## **PLANNING REVIEW CHECKLIST**

**Subject Property:** 5205 Battle Creek Road SE

**Reference Nos.:** 22-116522-PLN

(Class 3 Site Plan Review; Class 1 Design Review; Class 2 Adjustment;  
Tree Variance; Driveway Approach Permit)

Sheet No:  
T1.05

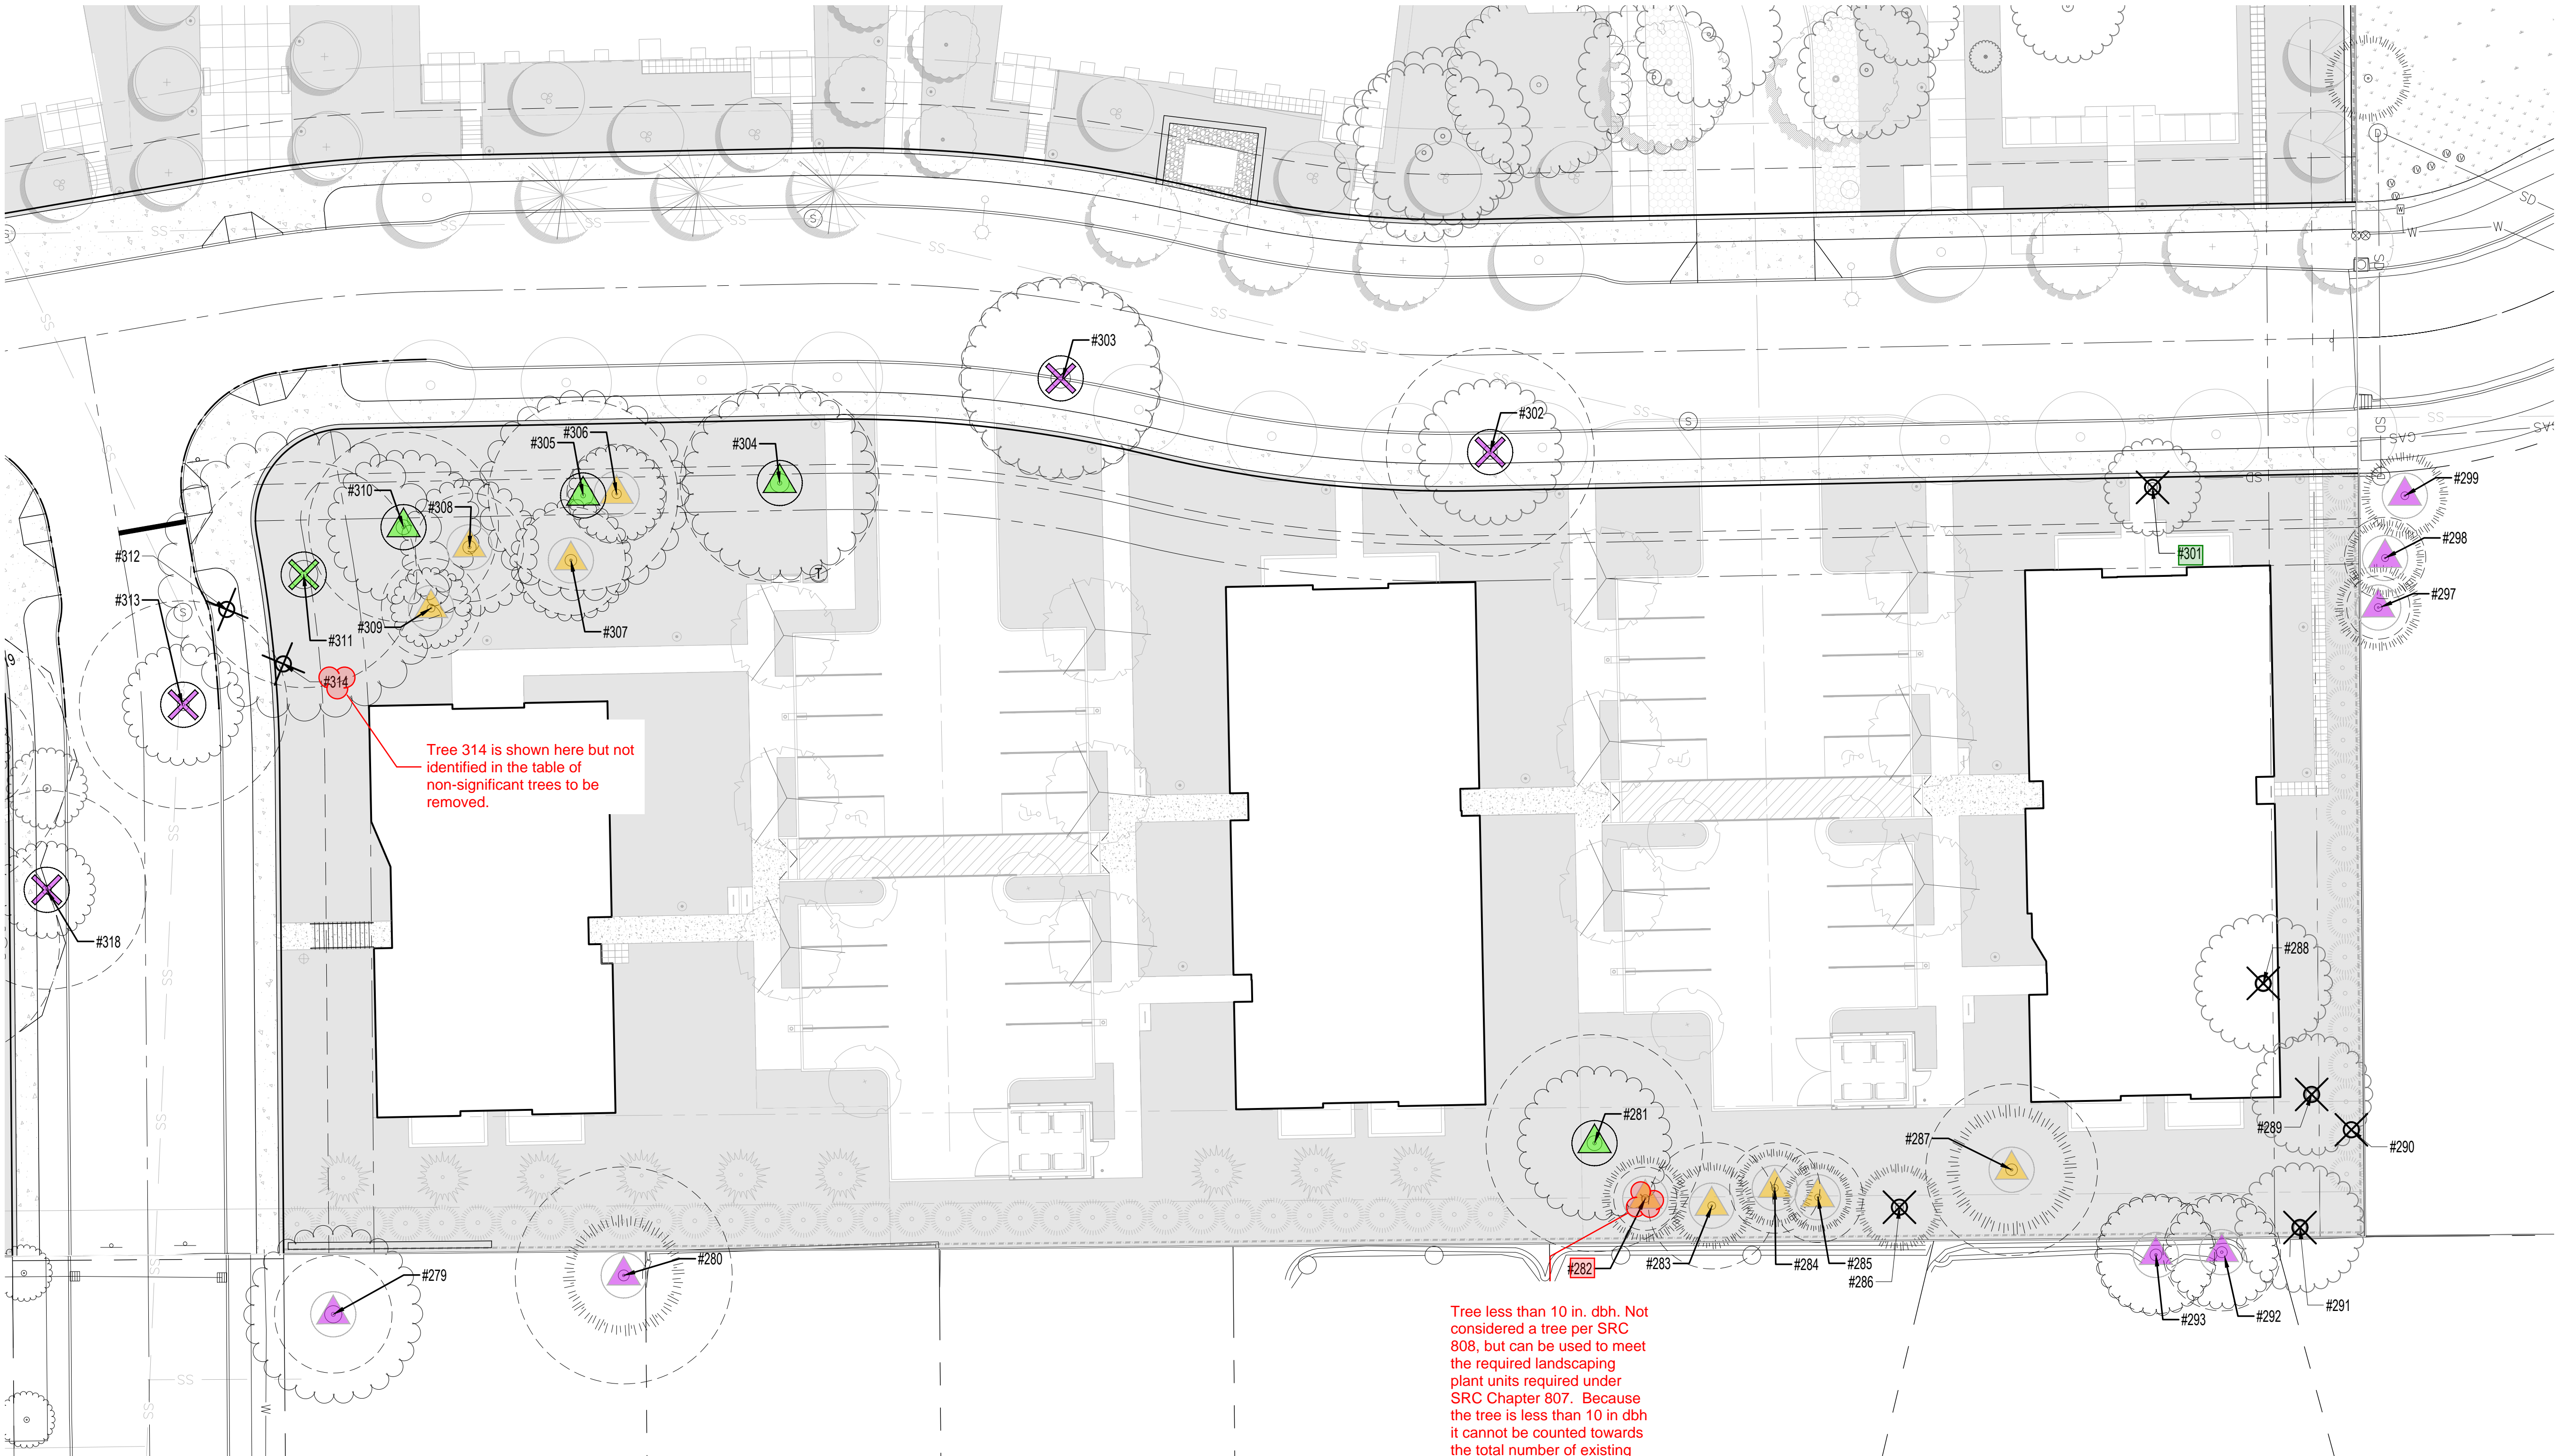
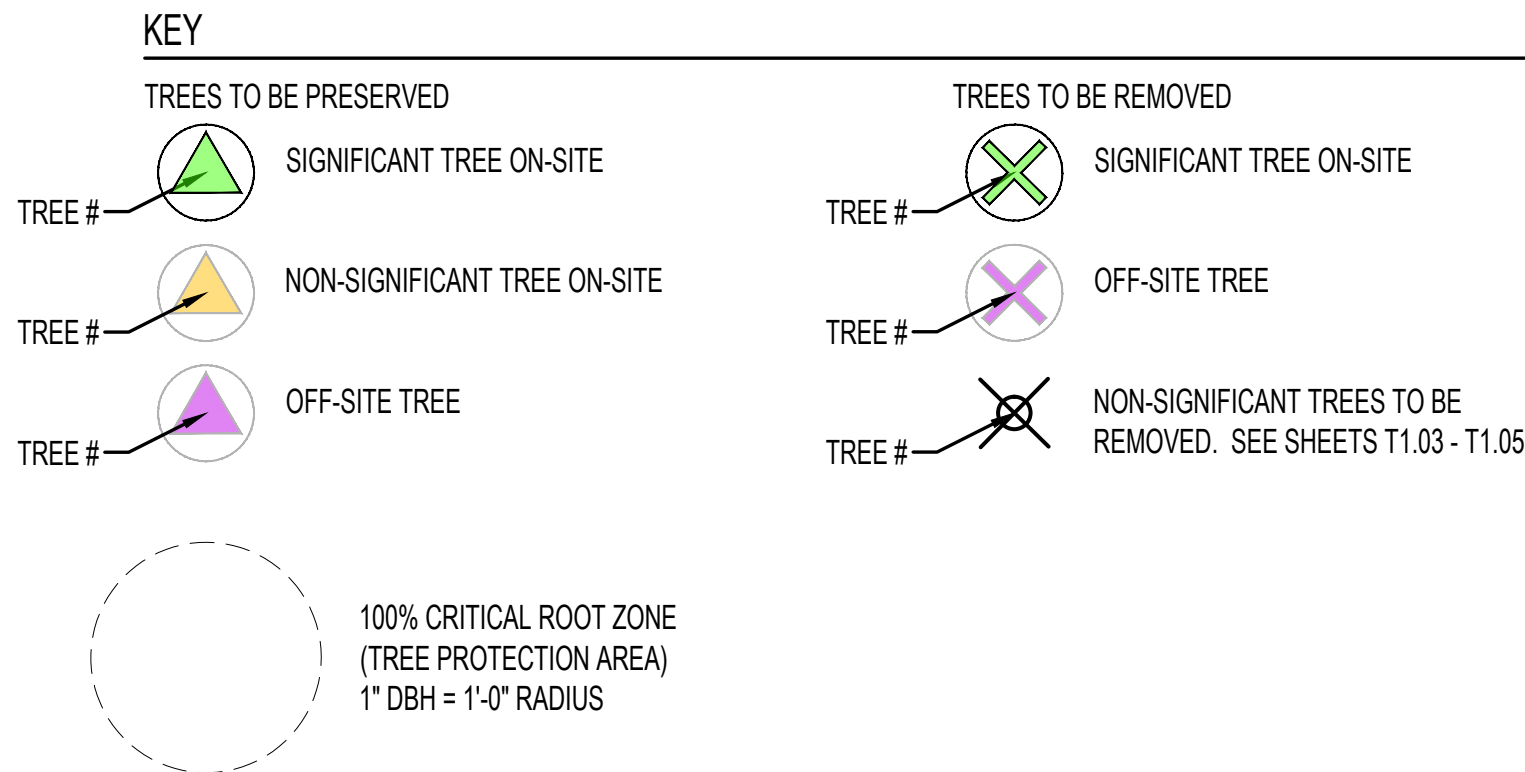
Tree less than 10 in. dbh. Not considered a tree per SRC 808, but can be used to meet the required landscaping plant units required under SRC Chapter 807. Because the tree is less than 10 in dbh it cannot be counted towards the total number of existing trees on the lot and it needs to be removed from the total tree count summary.
